**COMMENTS ON PLANNING APPLICATION 2015/0369/P
re 44 DARTMOUTH PARK ROAD**

Mr Kenneth Blyth, 27 Laurier Road NW5 1SH.

ENGINEERED EMINENT DOMAIN
GEOLOGICAL SURVEY MAP 1920
REVISED 1934

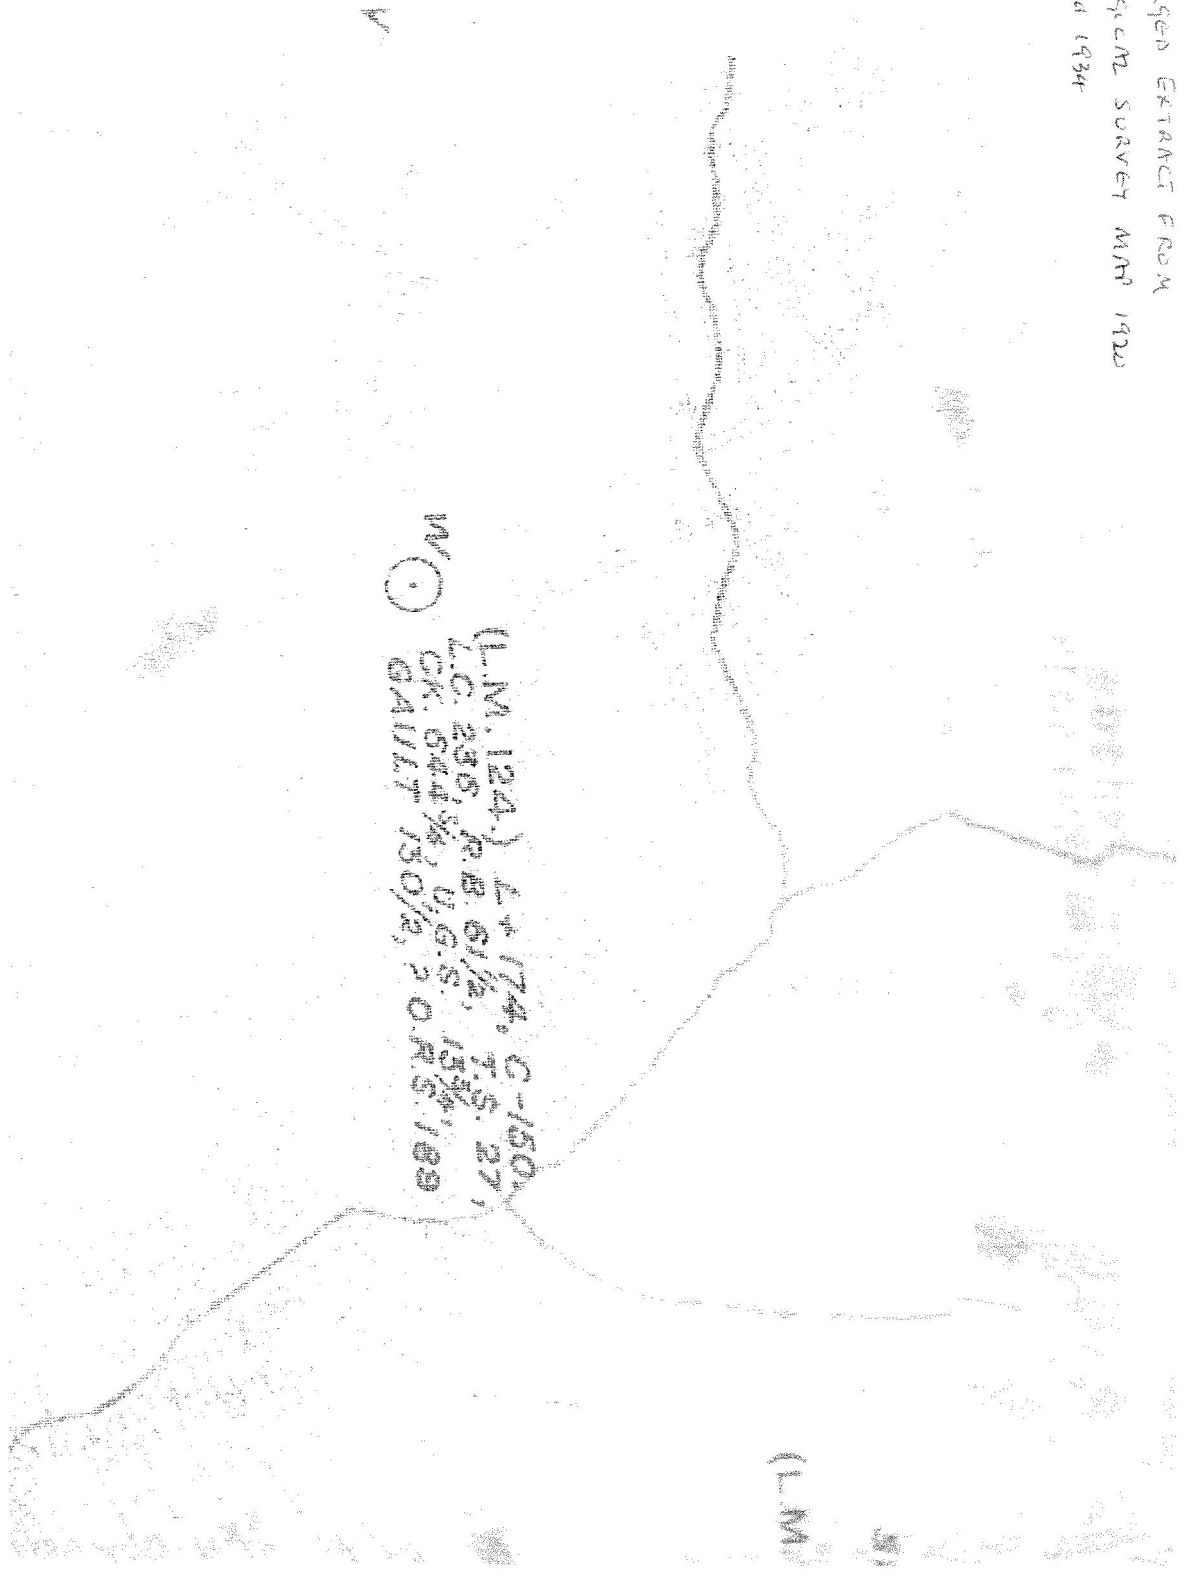
(iv) What the report says about the course of the old Fleet river is contrary to the information given in the Geological Survey map of the area.

4. In view of the risks of basement flooding known to local residents, the 'No' answers to questions (1a), (1b) and (6) are not convincing. Whether basement flooding is due to the existence of an aquifer or to changes in the height of the water table is not for a layman to say. But flooding occurs. As for question (2), the answer 'No' is linked to the statement, in section 2.8 of the report, that the site lies approximately 115m to the east of the historical River Fleet. That statement appears to be based on the small-scale sketch map at the end of Nigel Barton's *The Lost Rivers of London*. The six inches to the mile Geological Survey of England and Wales Edition of 1920, revised and published in 1934, differs from that. The Survey's London Sheet N II SW shows the line of the Fleet crossing the north-west corner of the garden of 44 Dartmouth Park Road, having crossed Laurier Road near number 25. An enlarged copy of the relevant section of the Geological Survey map is attached to this Appendix. (The section copied shows the river named as the 'Holeborne'. The full description on the complete map is 'Holeborne or Fleet Brook'.)
